Urgent Field Safety Notice

ACHC20-10.B1a.OUS.CHC June 2020

ADVIA® Chemistry 1800 ADVIA Chemistry 2400 ADVIA Chemistry XPT

Positive Bias Observed with Direct Bilirubin (DBIL_2) and Total Bilirubin (TBIL_2) Assays Following Calibration with Multiple Chemistry Calibrator Lots

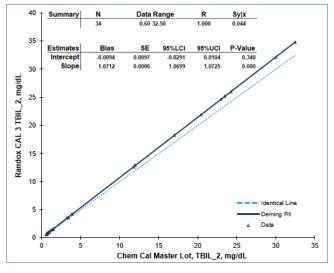
Additional lots of RANDOX Calibration Serum Level 3 (CAL 3) have been evaluated as a suitable alternative. In addition to RANDOX CAL 3 lot 1024UE, Siemens has verified the accuracy of RANDOX CAL 3 Lots 1014UE and 1162UE on the ADVIA Chemistry System by method comparison (see Figure 1 below). Results obtained at individual laboratories may vary. Siemens recommends that laboratories verify the accuracy of the results with acceptable QC performance when using the RANDOX CAL 3 Calibrator, prior to reporting of patient samples.

Note: Siemens has only verified the use of the RANDOX Calibration Serum Level 3 (CAL 3) Lots 1024UE ,1014UE and 1162UE to calibrate Direct Bilirubin (DBil_2) and Total Bilirubin (TBil_2). Siemens has not verified the performance of the other analyte constituents contained in the RANDOX CAL 3 product. Siemens is only recommending the use of verified RANDOX CAL 3 lots 1024UE, 1014UE and 1162UE.
